**Re: 2340 Ainger PL SE (Square 5740, Lot 0349),
24-Z-PDRM-00157**

This letter is to confirm the substance of the zoning Preliminary Design Review Meeting (“PDRM”) held on September 6, 2024, regarding property located at 2340 Ainger PL, SE (Square 5740, Lot 0349).

SQUARE 5740

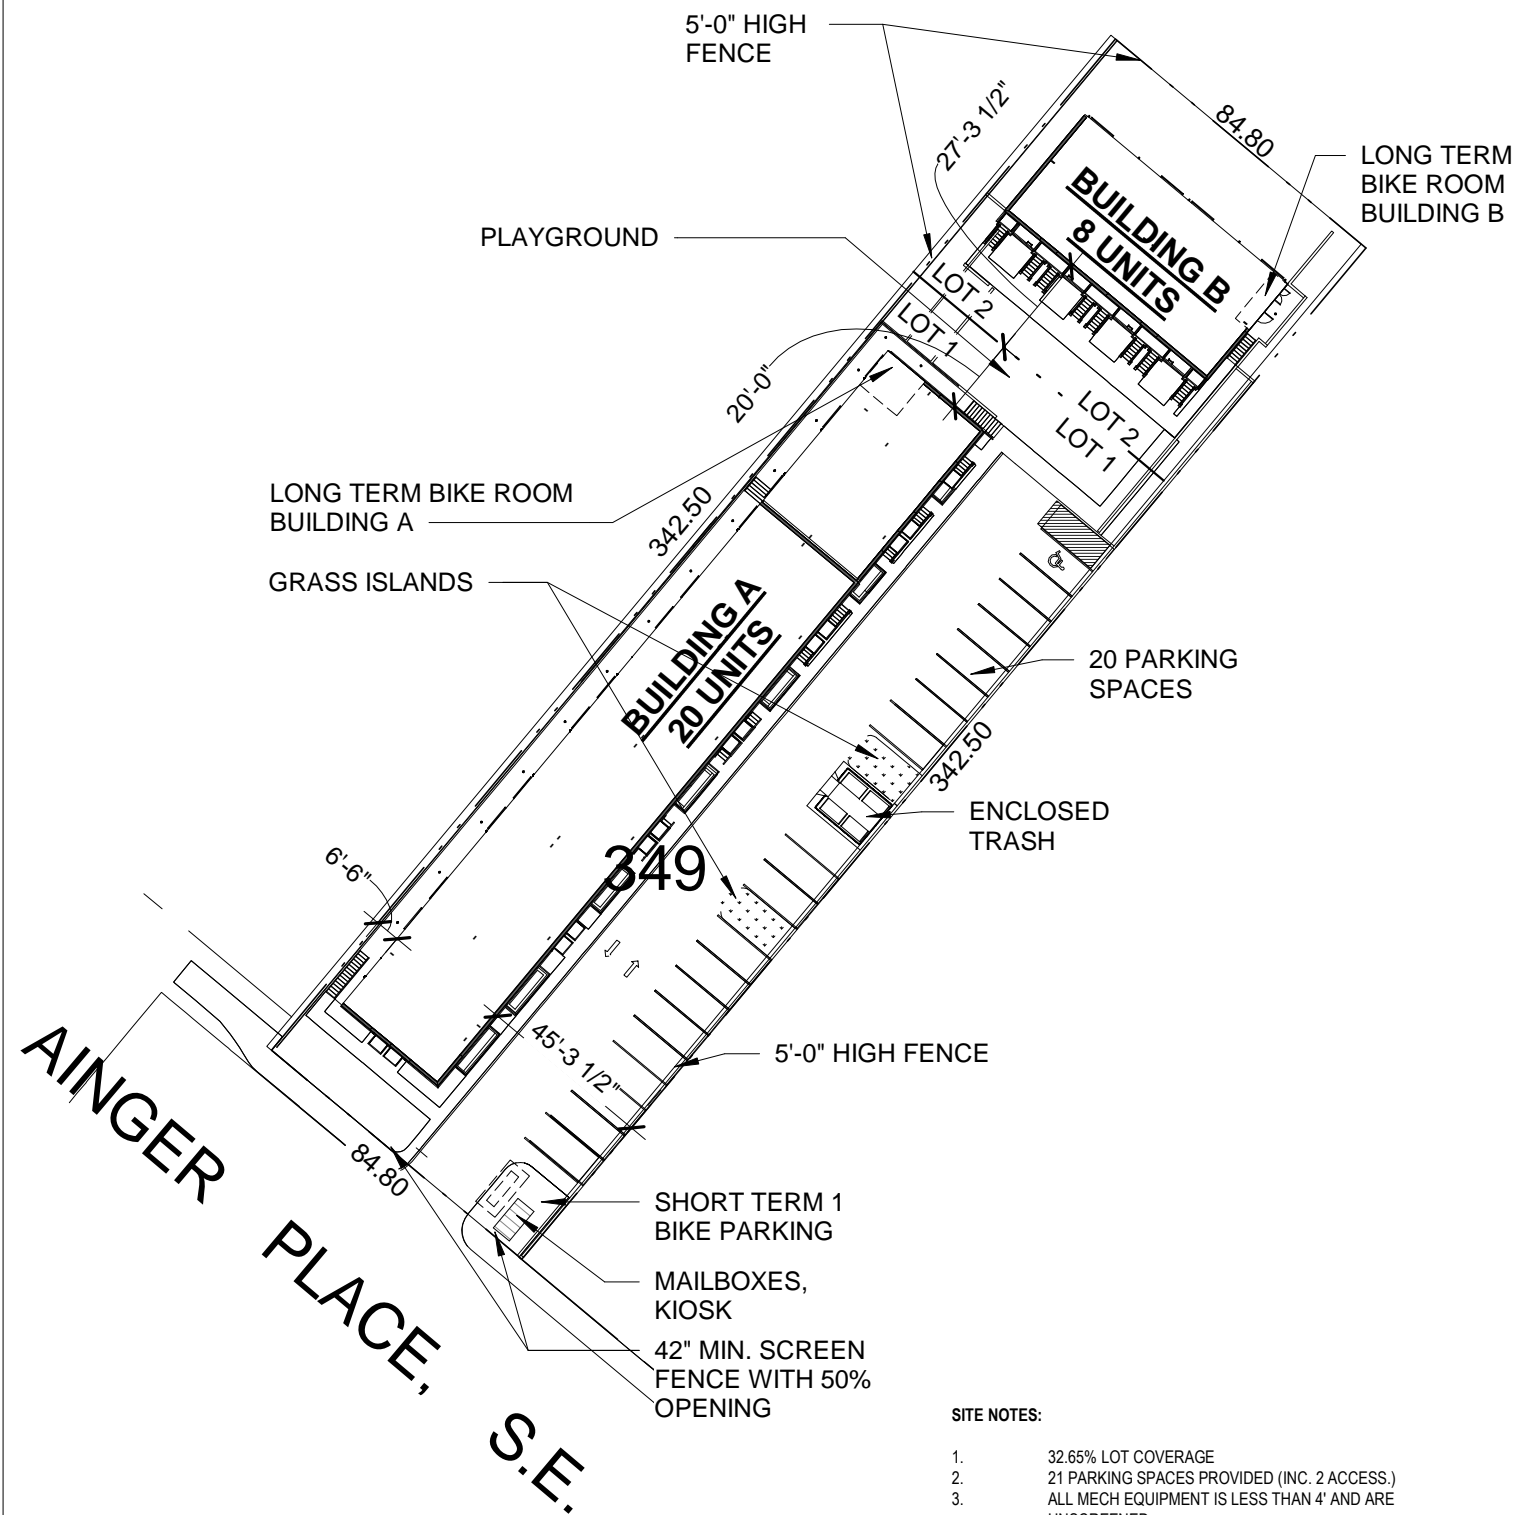
You are seeking confirmation that the orientation of the theoretical lots, as shown in the attached plat, including the location of the front, side, and rear yards, does not have to have any relation to the record lot orientation; meaning, the front yard of a theoretical lot does not have to face the front lot line. The proposed theoretical lots have two compliant side yards of at least 8 feet and one compliant rear yard of at least 20 feet, the proposal meets the side and rear yard requirements for theoretical lots and for the RA-1 zone.

Accordingly, if the project provides the two required 8-foot side yards, meets the Green Area Ratio (GAR) requirement, and all other applicable zoning requirements are met, then when you file the plans for a building permit with DOB, this office will approve the drawings that are consistent with the information noted above.
